OHIO SCIENTIFIC
SALES/TECHNICAL
NEWSLETTER # 22
November 9, 1979

2MHz UPDATES

FIGURE 2

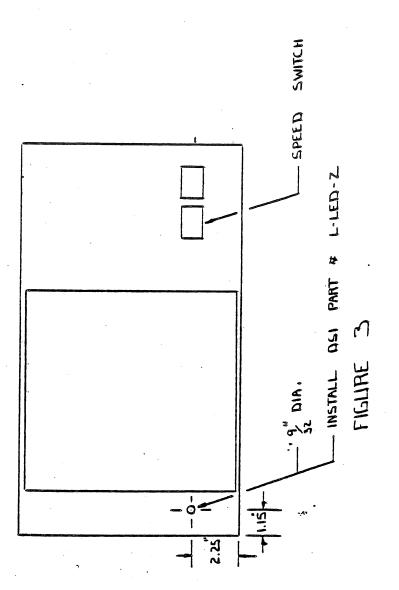
For C3-S1 and C3-OEM systems, modify the 580 backplane board as shown in Figure 1. The addition of four (4) 470 resistors is for addresses A16-A19. In addition, install a wire as shown in detail 1 to the front panel switch and LED indicator as shown in Figure 2. Mounting of the speed switch and LED for C3-OEM's is shown in Figure 3. Wiring is shown for C3-SI machines in Figure 4. Mounting of the speed switch and LED for C3-S1's is shown in Figure 5. Also, the +5 volt and ground wire for the switch and LED should originate from the backplane power bus.

Z-80 MEMORY ACCESS MOD

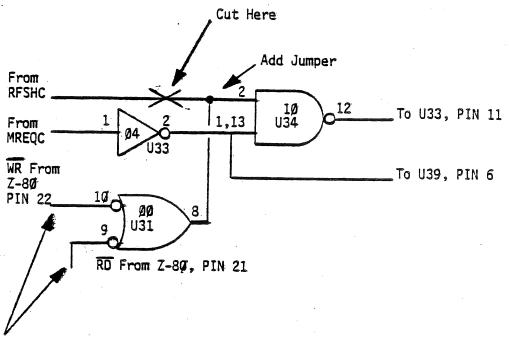
The SEMI-4200 RAM chips used on the 520 Static RAM boards are psuedo-Static Chips. These chips require a certain amount of "set up" time between accesses. They also require that the R/W line be defined before they are enabled. The original R/W circuitry could access memory in such a way that some 4200 chips would operate unreliably. This was due to the R/W line transition from READ to WRITE occurring as the chip was being enabled. The change shown prevents the 4200's from being enabled until the R/W line has stabilized.

Add Jumpers

(See Sheet 4 of 11, 510 Rev C Schematic)
